- 4. Sheet A100R3 FIRST FLOOR REMODEL PLAN - SEG A 30 x 42 attached hereto
 - a. Revisions clouded on Drawing
- 5. Sheet A103R1 SECOND FLOOR REMODEL PLAN - SEG B 30 x 42 attached hereto
 - a. Revisions clouded on Drawings
- 6. Sheet A601R2 DOOR SCHEDULE 30 x 42 attached hereto
 - a. Revisions clouded on Drawings
 - b. Door 224 removed from project
 - c. 1H2 changed from side coiling door to standard 3'-0" door

END OF DOCUMENT 00 90 00

Project Title: **WESTERN TECHNICAL COLLEGE
ARC & WELCOME CENTER PHASE 2 REMODEL**
Project Location: 400 N. 7TH STREET
LA CROSSE, WI 54601
Sheet Title: **FIRST FLOOR REMODELED PLAN - SEG A**

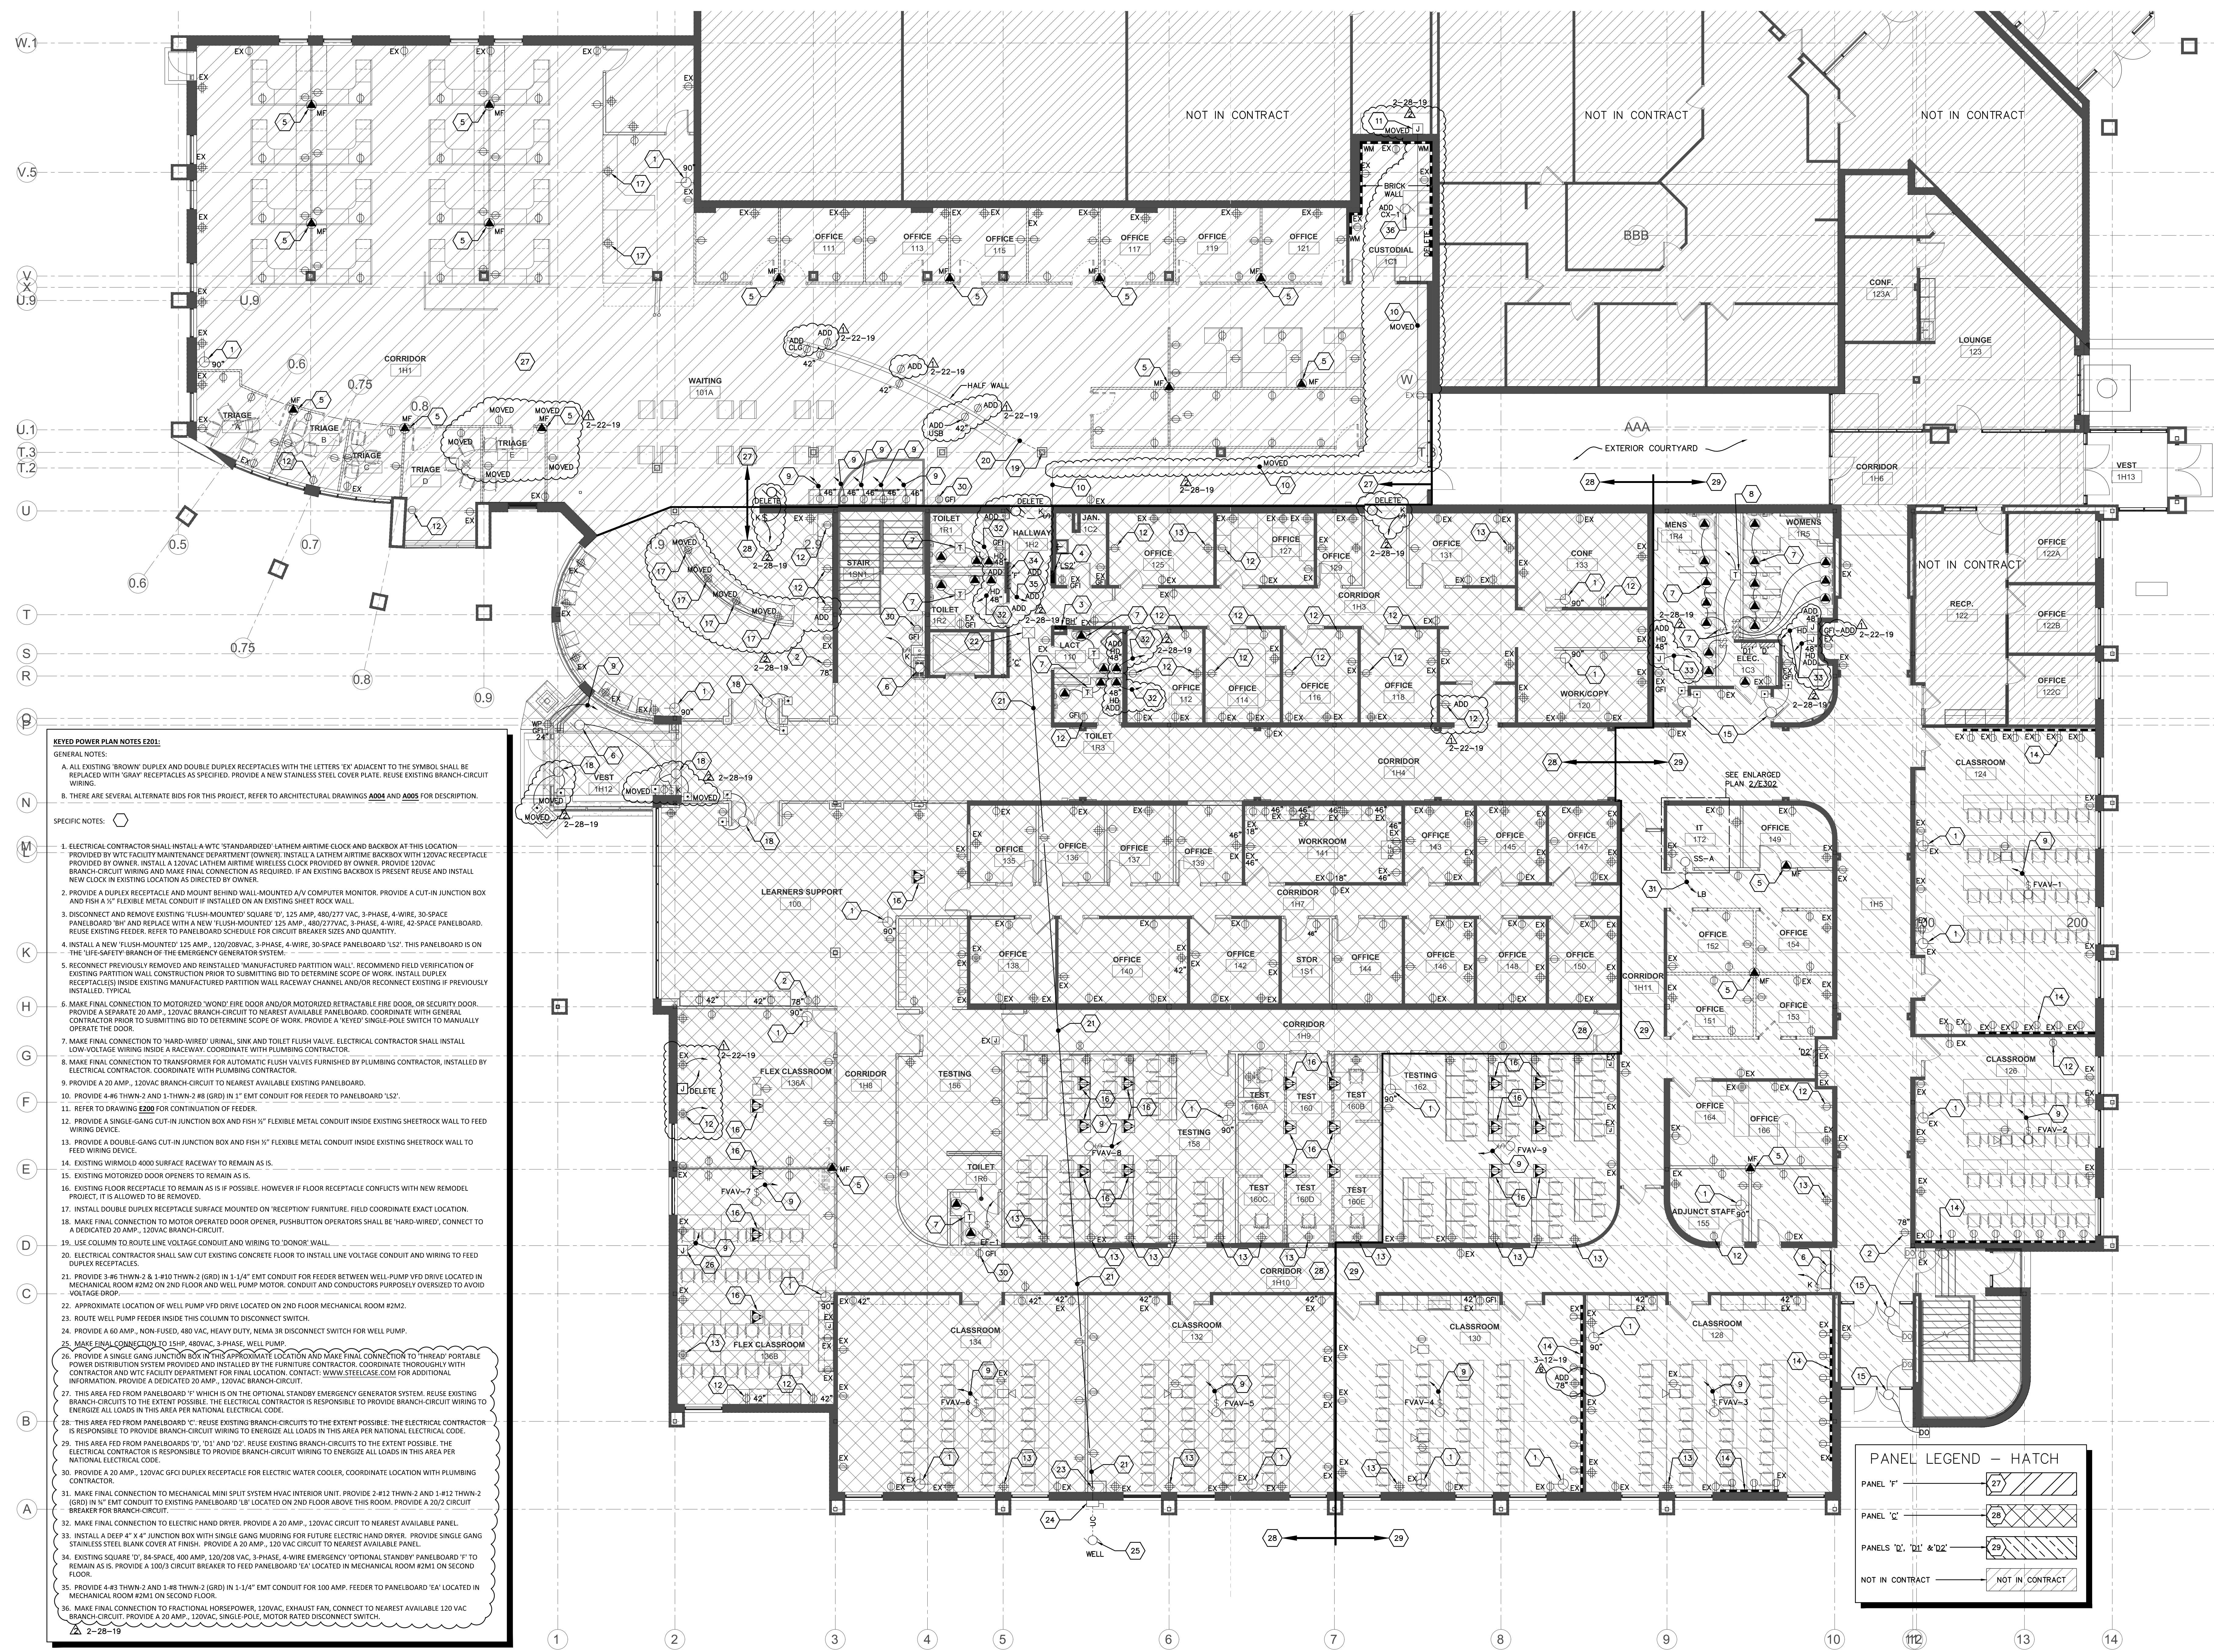
- b. Provide a double duplex receptacle for wall-mounted monitor in classroom #130.
19. Sheet E301R2 PARTIAL FIRST FLOOR LOW VOLTAGE PLAN 30 x 42 attached hereto

E301R.2

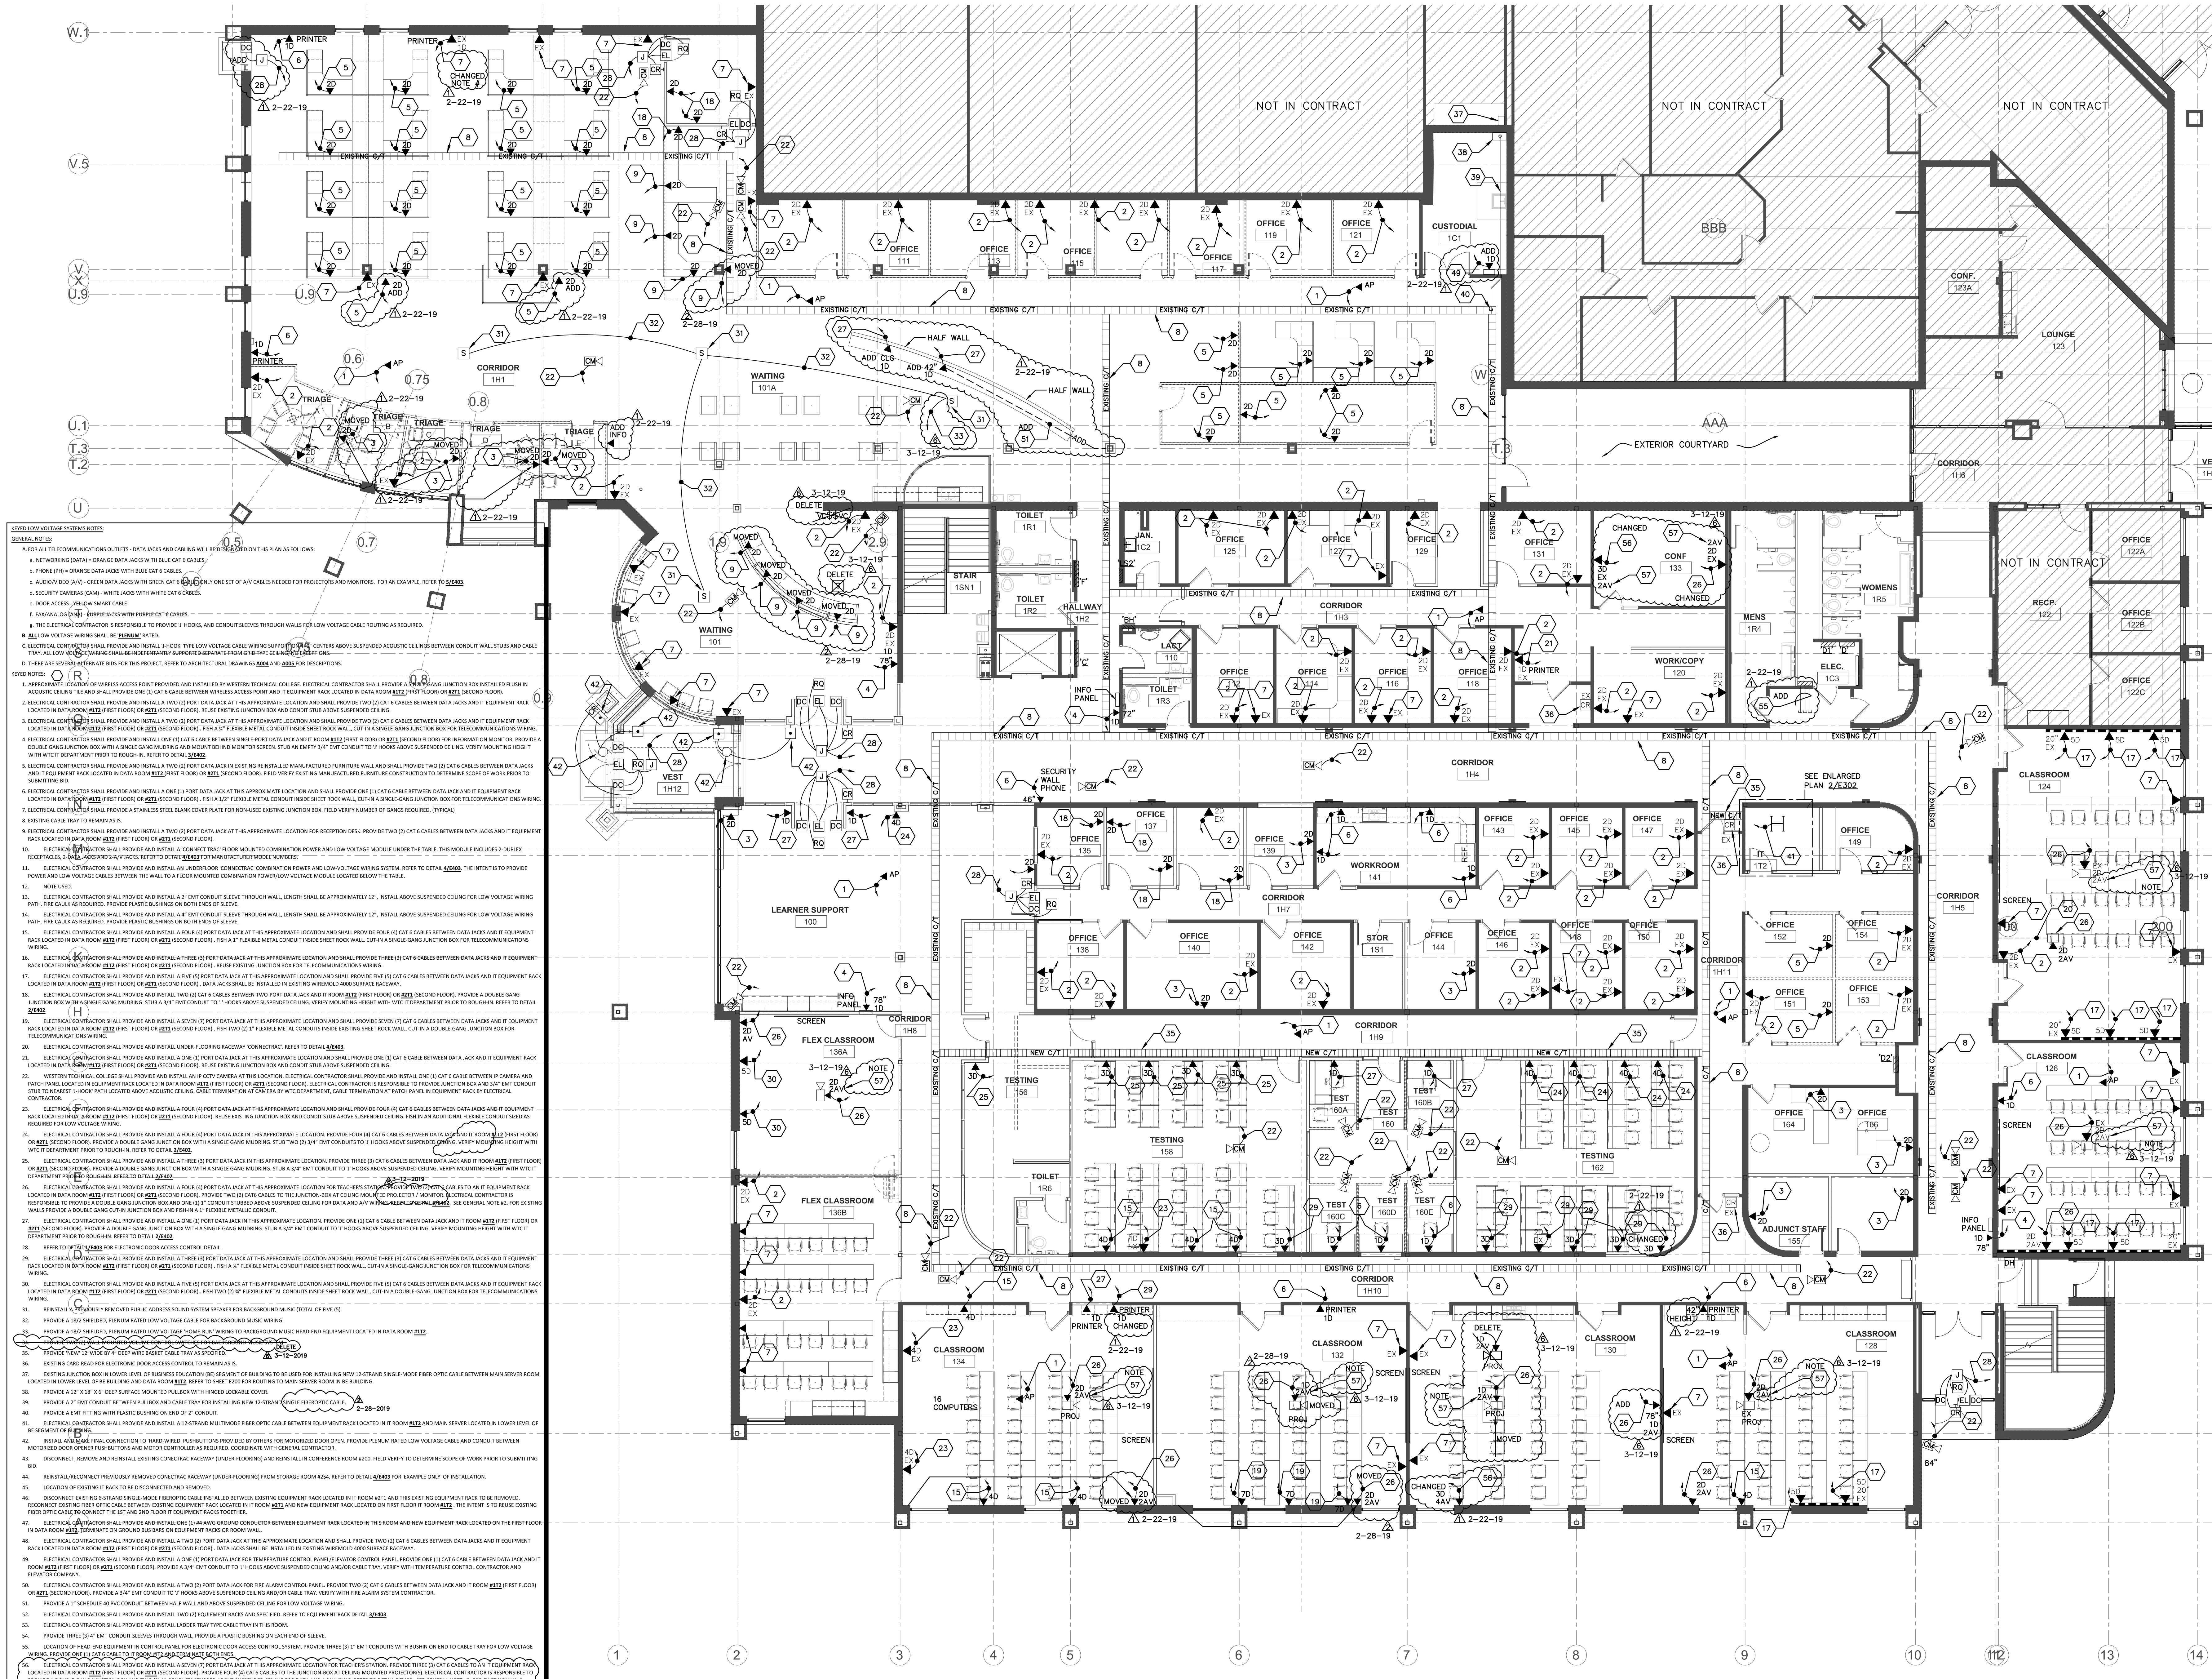
- a. Drawing added to Contract documents
 - b. In classrooms #124, 126, 128, 130, 132, 134, 136A and conference room #133 provide CAT6-A cable with 10 Gigabit networking for all A/V jacks. Coordinate with WTC IT department. All applications for video, audio editing/processing, AutoCad, SQL databases, file transfers & roaming profiles on domain controllers require CAT6A cabling

- IN CLASSROOMS #124, 126, 128, 130, 132, 134, 136 AND CONFERENCE ROOMS #133 AND #100 PROVIDE CAT 6 CABLE WITH 10 GIGABIT NETWORKING FOR ALL AV JACKS. COORDINATE WITH WTC IT DEPARTMENT. ALL APPLICATIONS FOR VIDEO, AUDIO RECORDING, INTERACTIVE, 3D, AND 4K. FILE TRANSFERS TO RECORDING DEVICES OR STORAGE CONTROLLERS REQUIRE CAT 6 CABLES. REFER TO DETAIL 21602.
